FLYING HORSE NORTH FILING NO. 3
CONSTRUCTION DOCUMENTS

AS-BUILT VERSION 1.0, DATED 7/15/2026
PE: RICHARD LYON
CO PE NO. 53921

FLYING HORSE NORTH FILING 3
PRI #2, LLC.
EL PASO COUNTY, CO

SHEET
ST 12

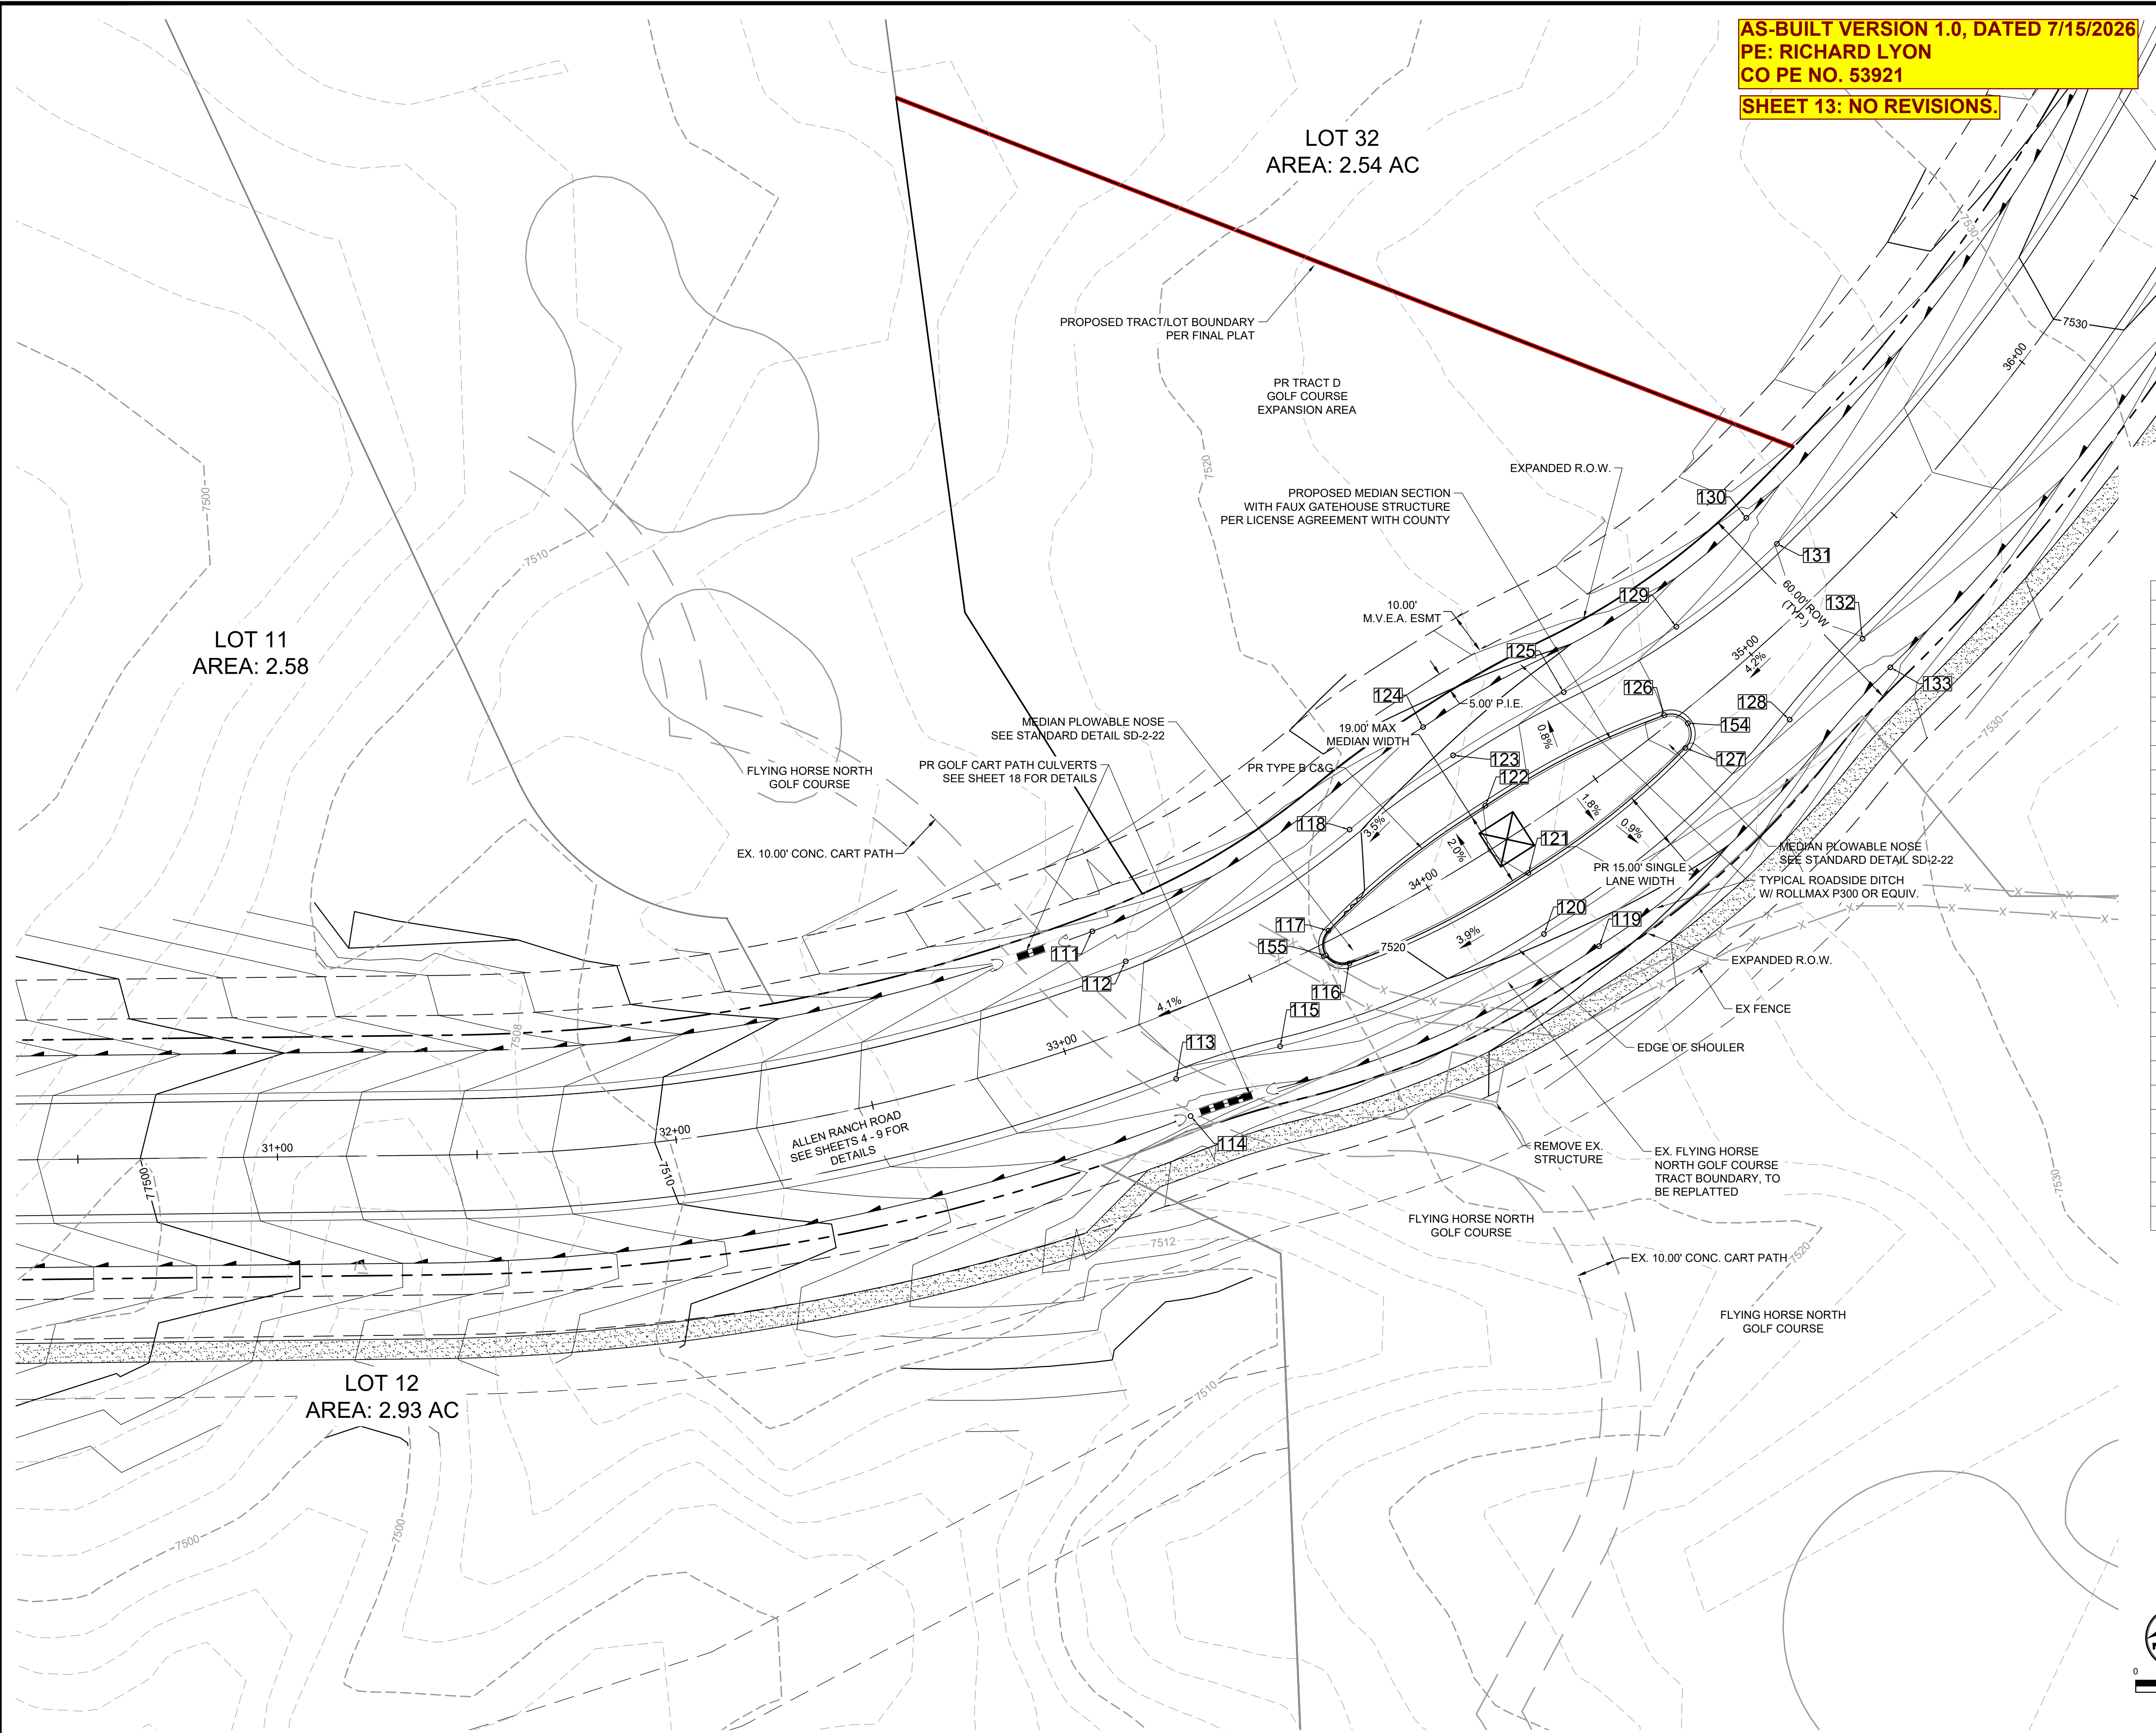
AS-BUILT VERSION 1.0, DATED 7/15/2026
PE: RICHARD LYON
CO PE NO. 53921
SHEET 12:
- TYPICAL ALL SHEETS WHERE
APPLICABLE: EXPOSED RIP-RAP
AT CULVERT PIPES TO BE BURIED
SOIL RIP-RAP WITH 4" TOPSOIL.

SHEET
ST
16

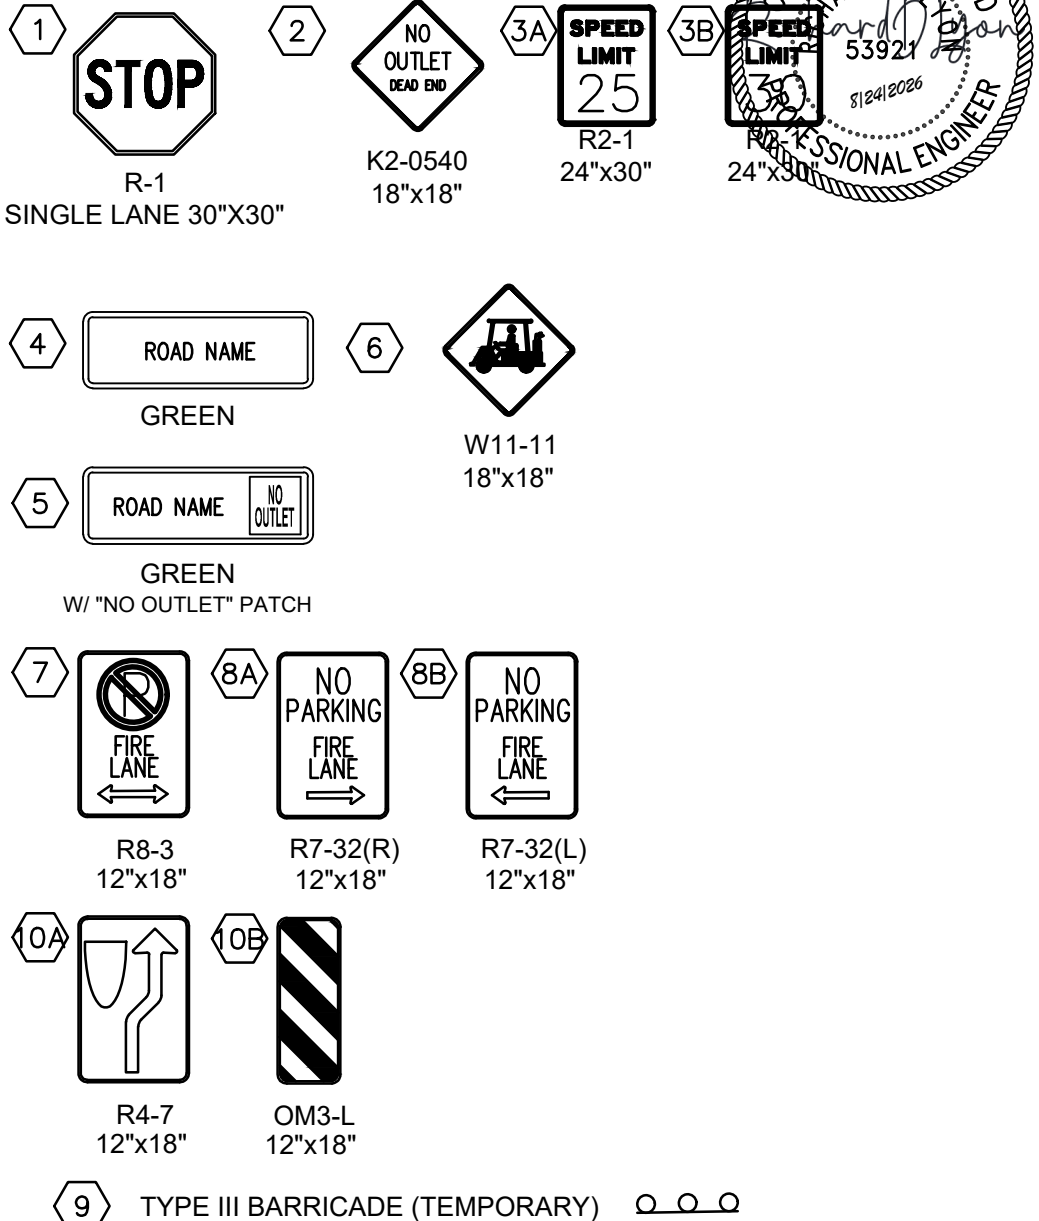
Please replace this sheet with the revised Striping and Signage Plan (approved on 09/17/2026), which reflects the updated cart-crossing signage and striping.

SHEET
STM
18

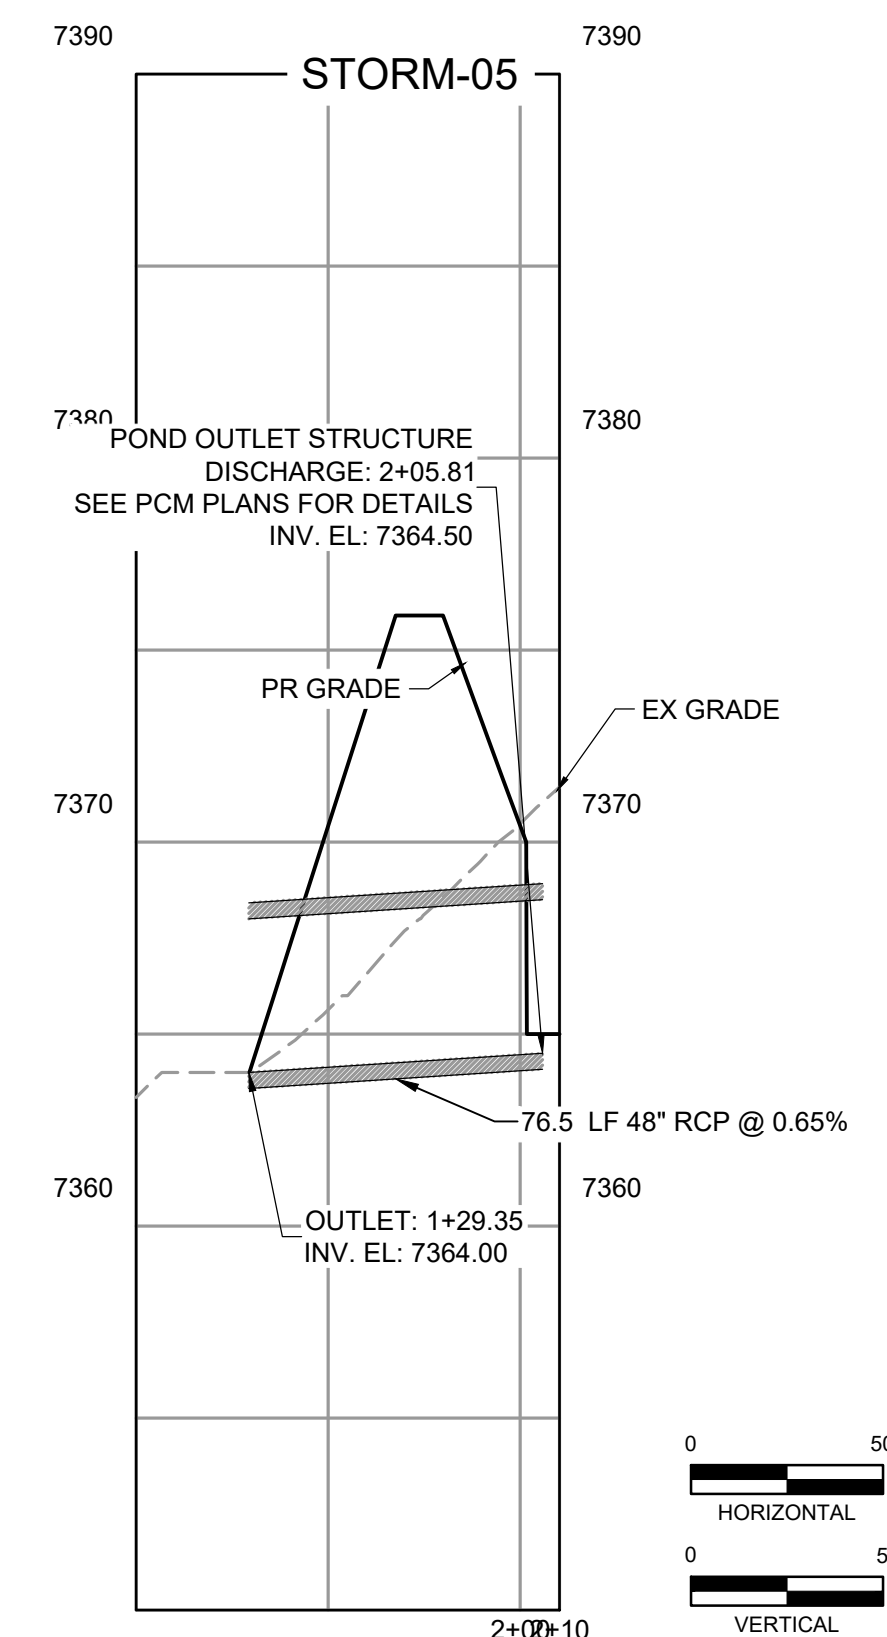
SHEET 18:
- TYPICAL ALL SHEETS WHERE
APPLICABLE: EXPOSED RIP-RAP
AT CULVERT PIPES TO BE BURIED
SOIL RIP-RAP WITH 4" TOPSOIL.

21

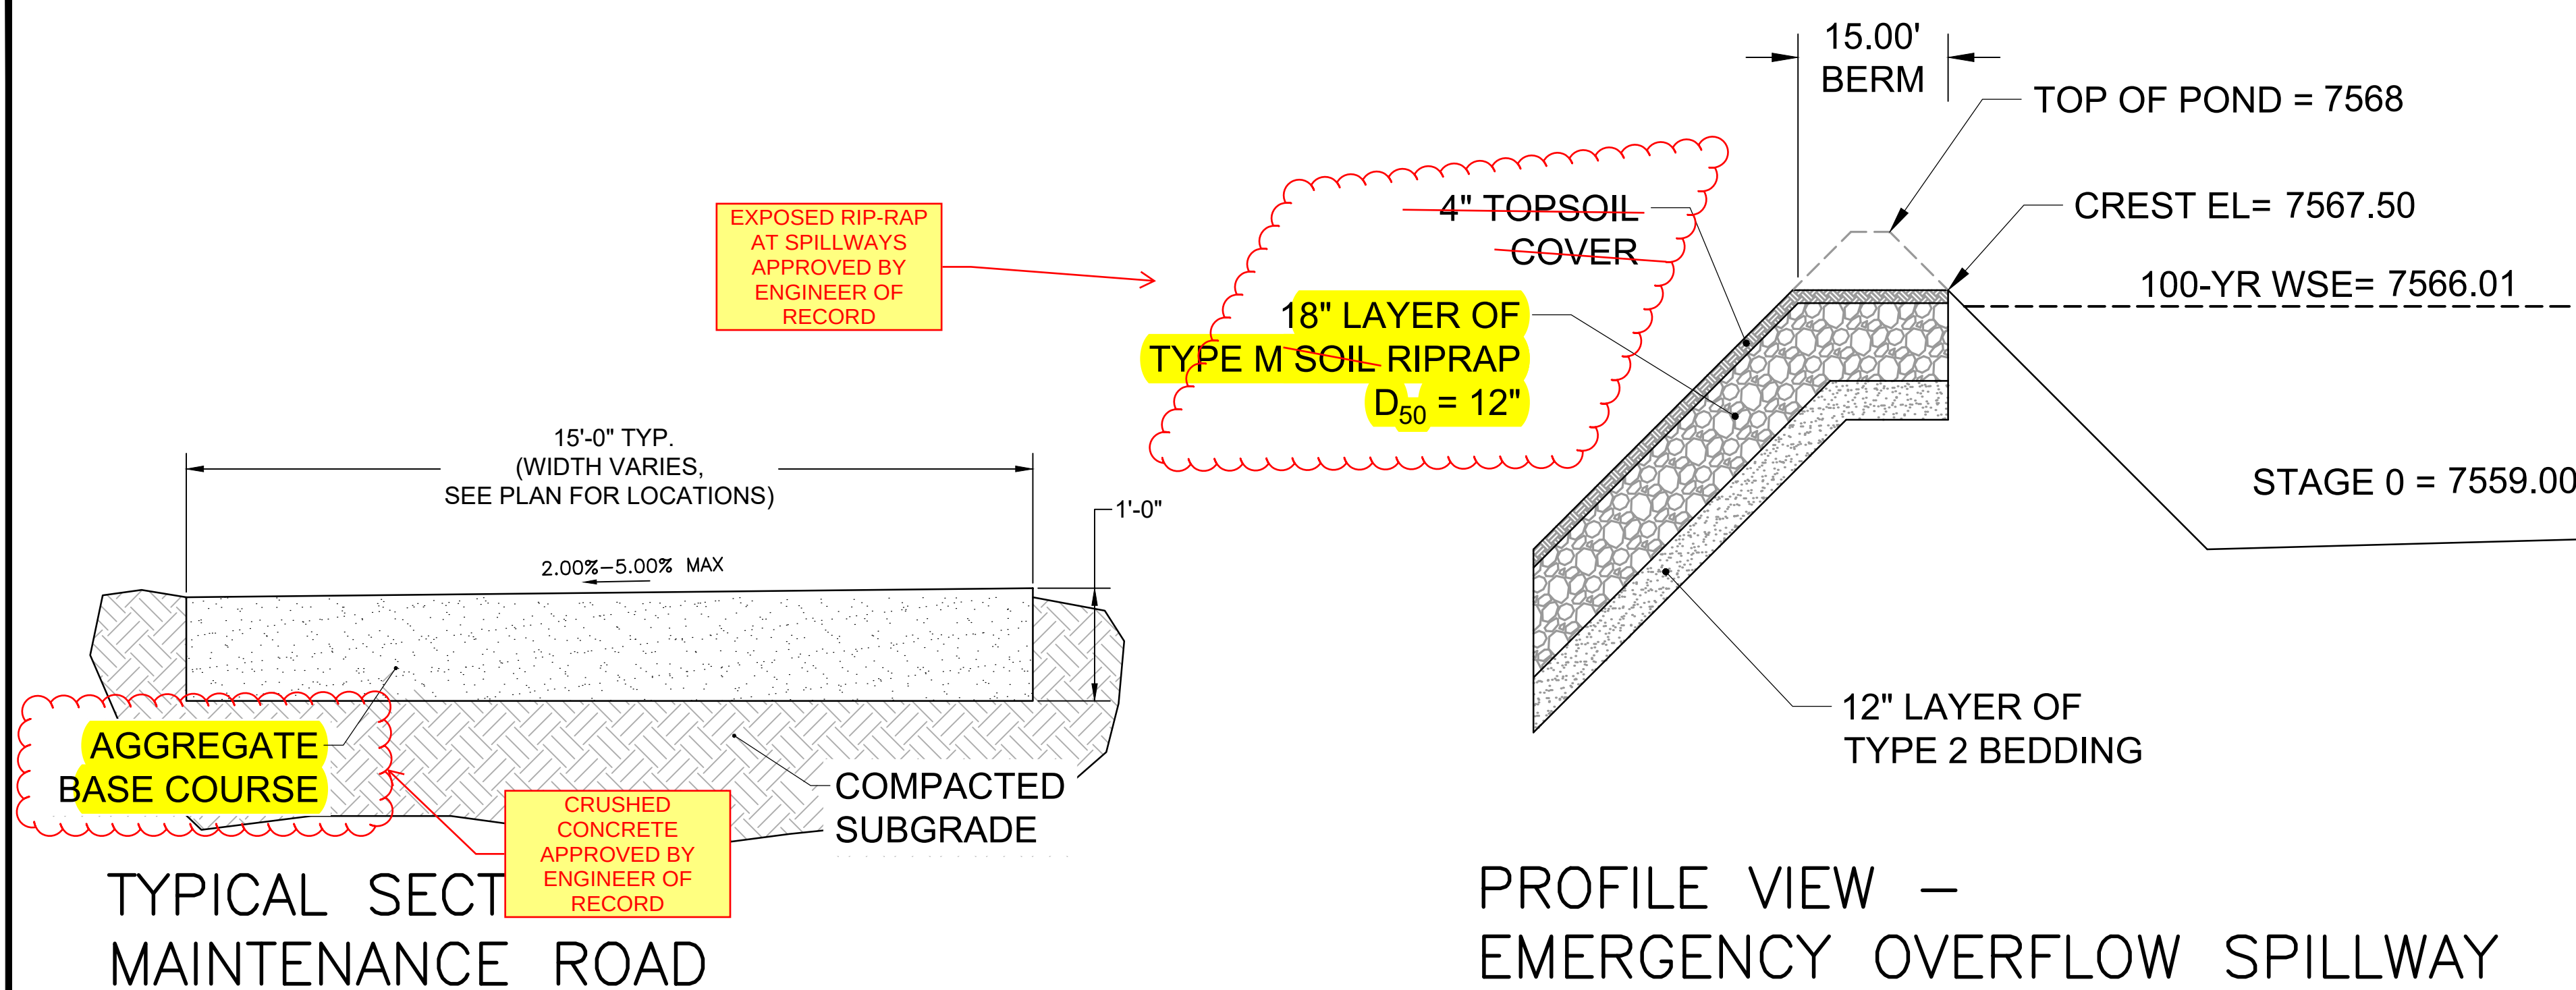
- CRUSHED CONCRETE FOR POND B MAINTENANCE ACCESS
- MICROPOOL ADJUSTMENT PER FIELD CONDITIONS

AS-BUILT CALCS PROVIDED.

SECTION VIEW - EMERGENCY OVERFLOW SPILLWAY

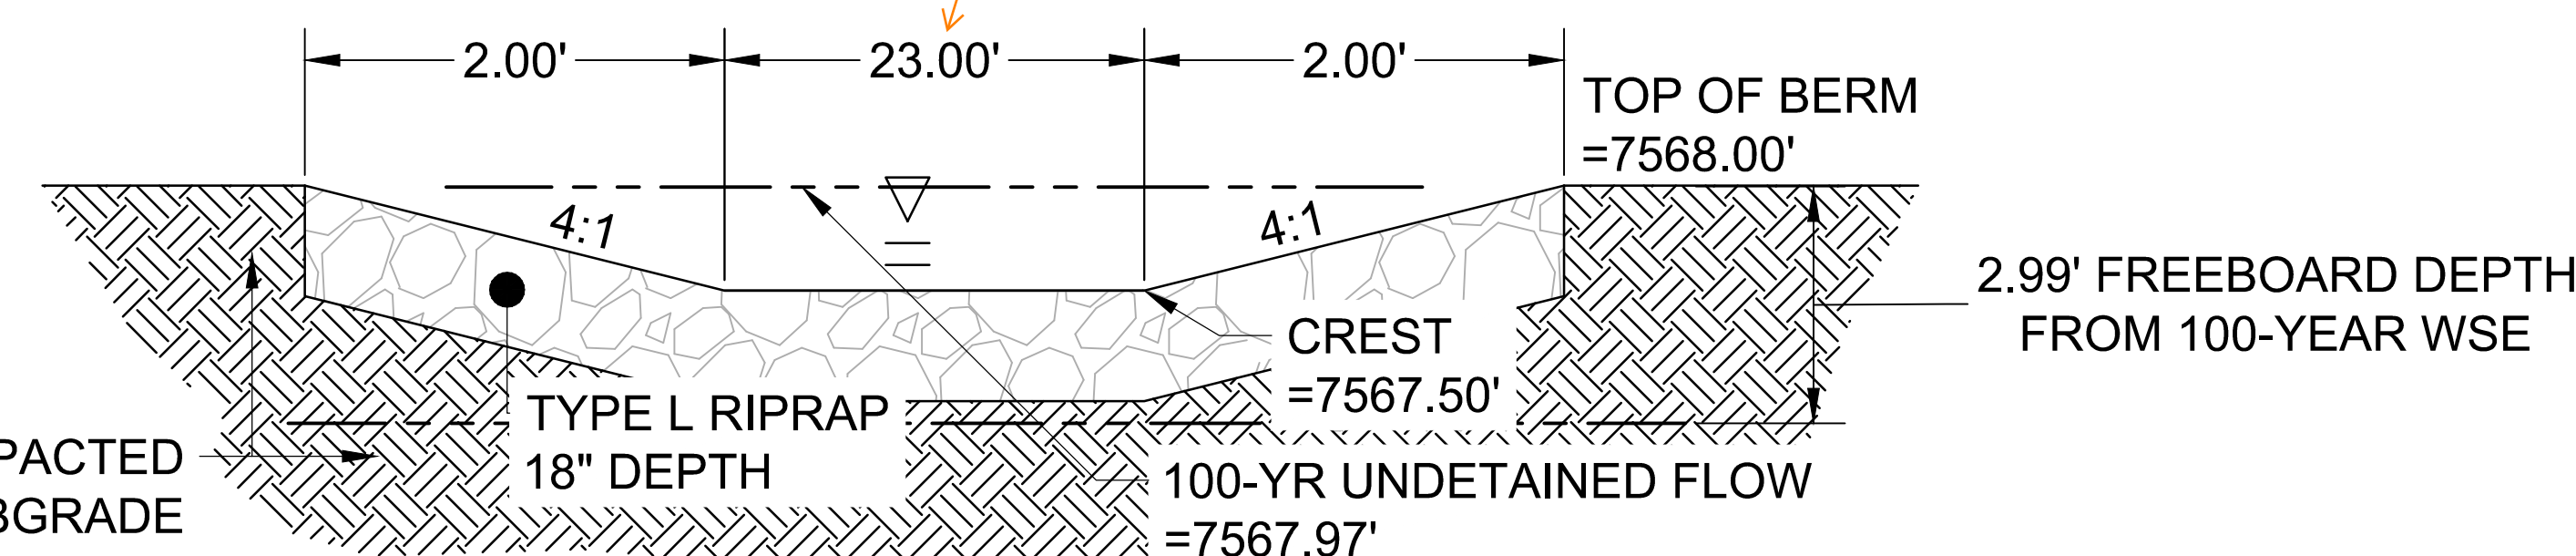
**SHEET 23:
- SECTION VIEW
REMOVAL OF 4" OF
TOPSOIL, EXPOSED
RIP-RAP ALLOWED BY
E.O.R. FOR SPILLWAYS
AT PONDS**
